# EWR Route Analysis

Jon Shortland

Chief Officer for Planning,  
Infrastructure and Economic Growth

- This diagram from EWR shows how a track arrangement could work:

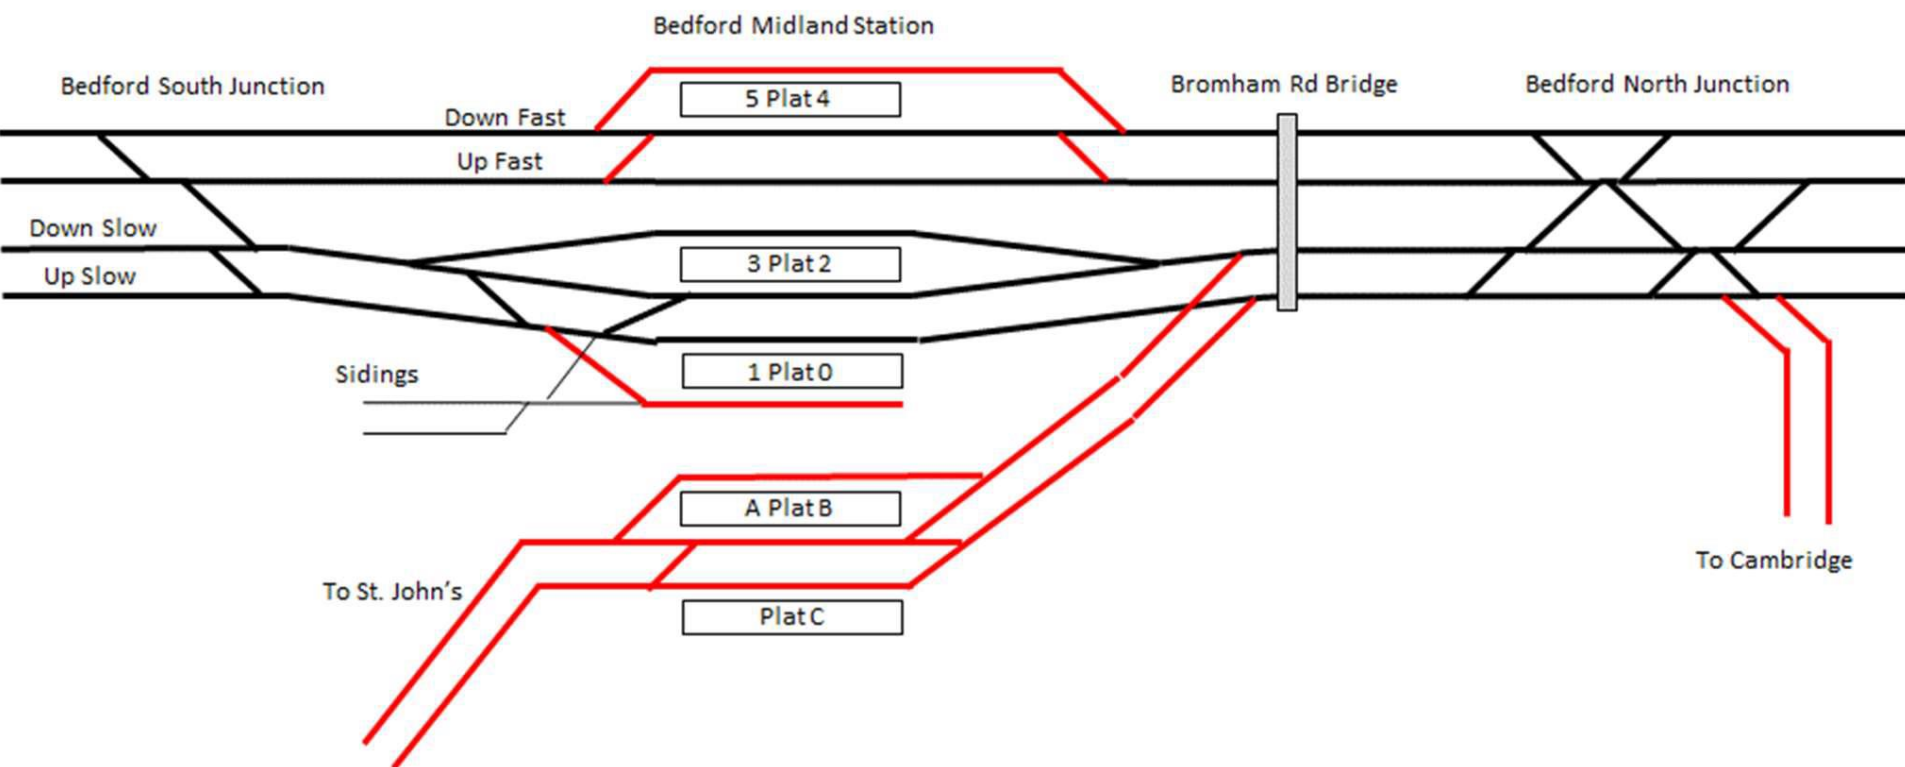
- SLC have set out the following findings:
  - Platform 3 should be clear for much of the day, as GTR services would still have three platforms to use (more than the current 2½) as EMR services would use platforms 4-5.
  - It would then be possible to hold a freight in that platform, thus breaking the link between EWR and GTR services.
  - It is recommended that EWR Co is asked to demonstrate whether this could be made to work.
